PROPOSED.

DONKEY BOILER.

No 227

S.S. "Dabulamanzi"
Aberdeen
7/6/82
E.S.

SECTION ON LINE A. B.

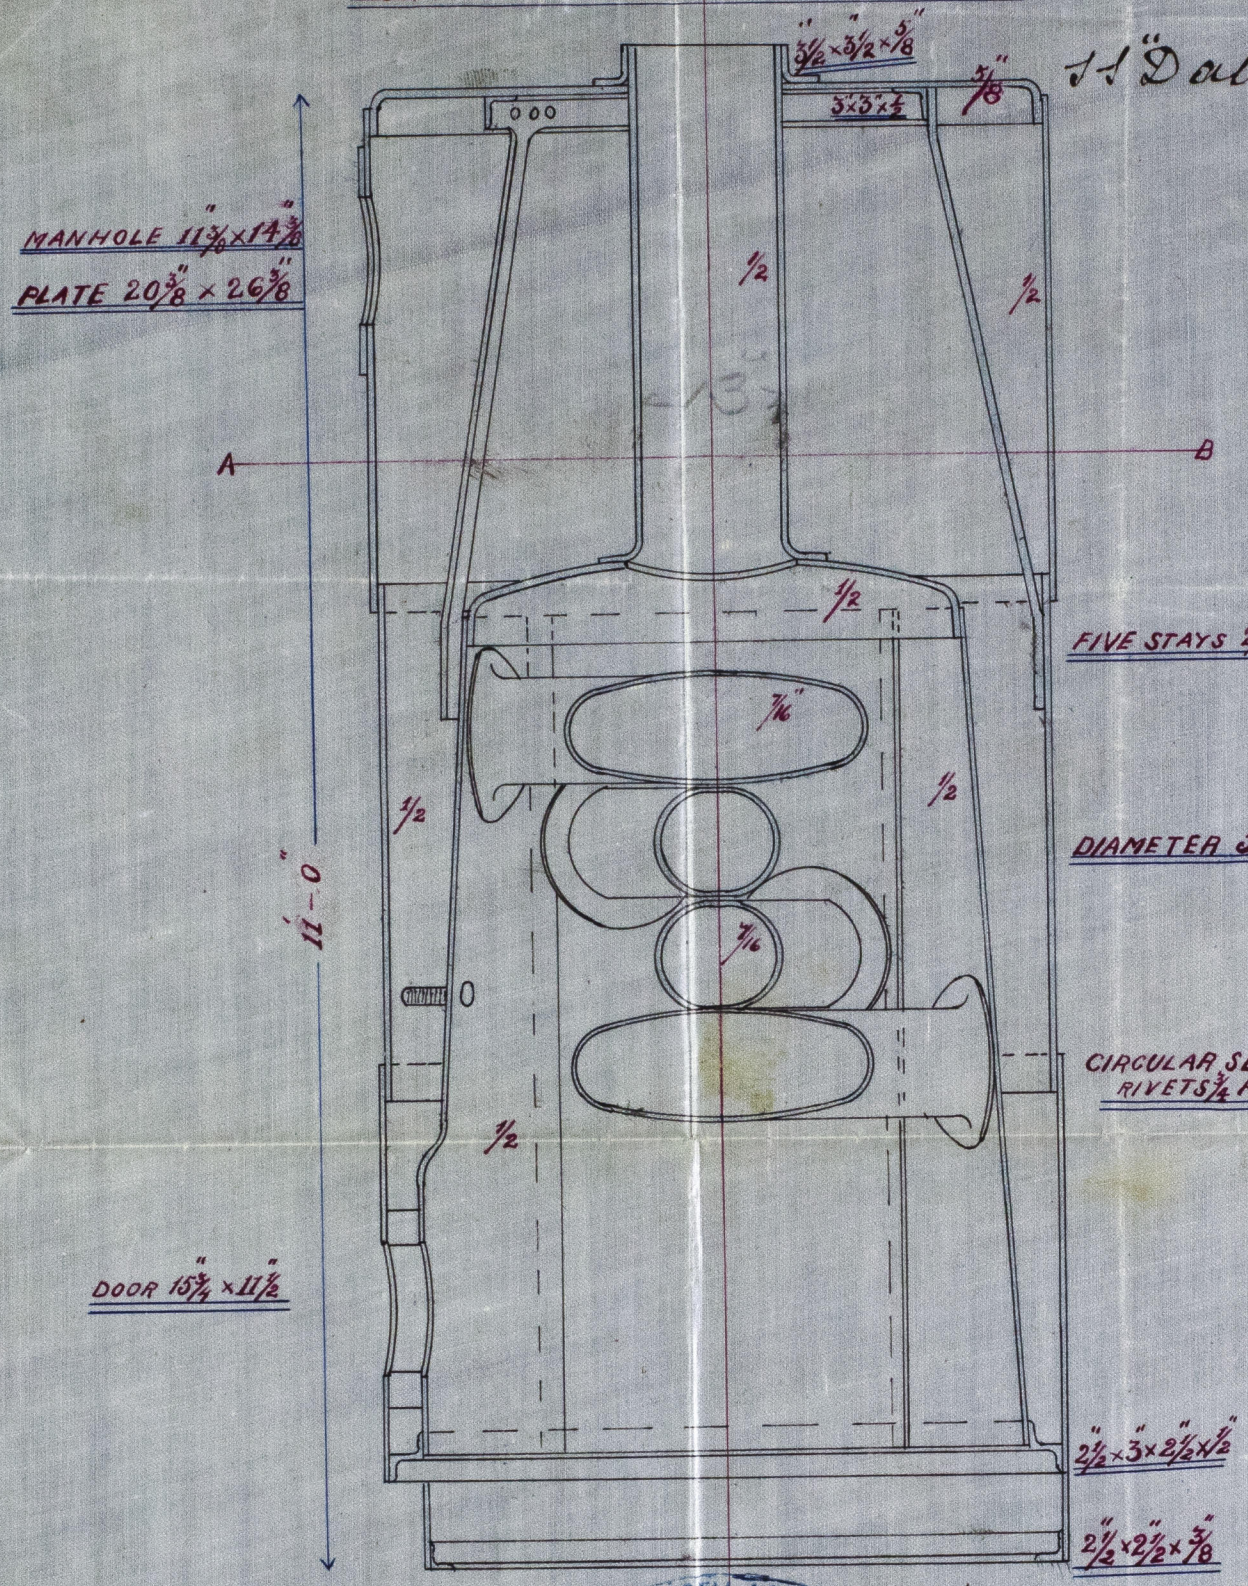
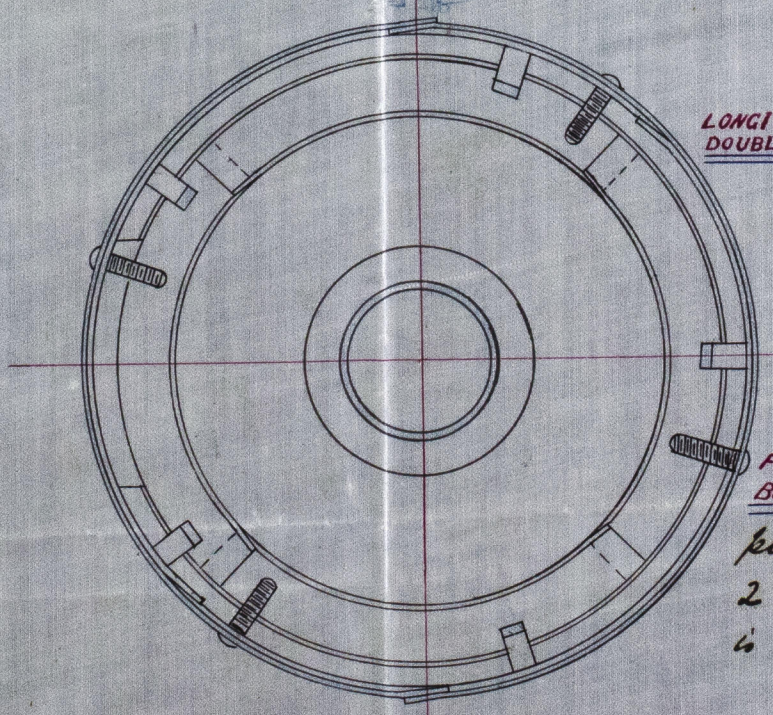
positions to be such that with 2 lower tube ends the furnace is supported all round
